Product Change Notice (PCN)

Subject: Add Assembly and Sorting Site for RL78/L12 LQFP44pin Package Products

Group name: RL78/L12

Target package: 10mm×10mm 0.8mm pitch 44pin LQFP

Package Outline (Greatek)

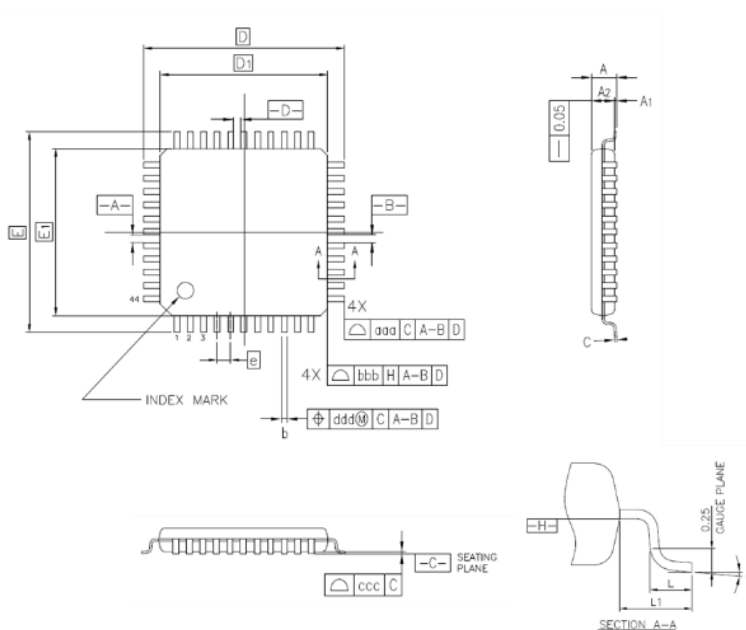
Dimension Comparison

Beijing Symbol	PLQP0044GF-A			Greatek Symbol	PLQP0044GE-A			KL Symbol	PLQP0044GC-A			ASEKH Symbol	PLQP0044GC-D		
	Dimension in Millimeters				Dimension in Millimeters				Dimension in Millimeters				Dimension in Millimeters		
	Min	Nom	Max		Min	Nom	Max		Min	Nom	Max		Min	Nom	Max
A	-	-	1.70	A	-	-	1.60	A	-	-	1.60	A	-	-	1.60
A1	0.05	-	0.15	A1	0.05	-	0.15	A1	0.05	0.10	0.15	A1	0.05	-	0.15
A2	1.35	1.40	1.45	A2	1.35	1.40	1.45	A2	1.35	1.40	1.45	A2	-	1.40	-
D	-	12.00	-	D	-	12.00	-	HD	11.80	12.00	12.20	HD	11.80	12.00	12.20
D1	-	10.00	-	D1	-	10.00	-	D	9.80	10.00	10.20	D	9.80	10.00	10.20
E	-	12.00	-	E	-	12.00	-	HE	11.80	12.00	12.20	HE	11.80	12.00	12.20
E1	-	10.00	-	E1	-	10.00	-	E	9.80	10.00	10.20	E	9.80	10.00	10.20
N	-	44	-	N	-	44	-	-	-	-	-	-	-	-	-
e	-	0.80	-	e	-	0.80	-	e	-	0.80	-	e	-	0.80	-
b	0.30	0.37	0.45	b	0.30	0.37	0.45	b	0.30	0.37	0.45	bd	0.22	0.37	0.45
c	0.09	-	0.20	c	0.09	-	0.20	c	0.10	0.145	0.20	c	0.09	-	0.20

θ	0°	3.5°	8°	θ	0°	3.5°	7°	θ	0°	3°	8°	θ	0°	3.5°	8°
L	0.45	0.60	0.75	L	0.45	0.60	0.75	Lp	0.45	0.60	0.75	Lp	0.45	0.60	0.75
L1	-	1.00	-	L1	-	1.00	-	L1	0.80	1.00	1.20	L1	-	1.00	-
aaa	-	-	0.20	aaa	-	-	0.20	-	-	-	-	-	-	-	-
bbb	-	-	0.20	bbb	-	-	0.20	-	-	-	-	-	-	-	-
ccc	-	-	0.10	ccc	-	-	0.10	y	-	0.10	-	y	-	0.10	-
ddd	-	-	0.20	ddd	-	-	0.20	x	-	0.20	-	x	-	0.20	-
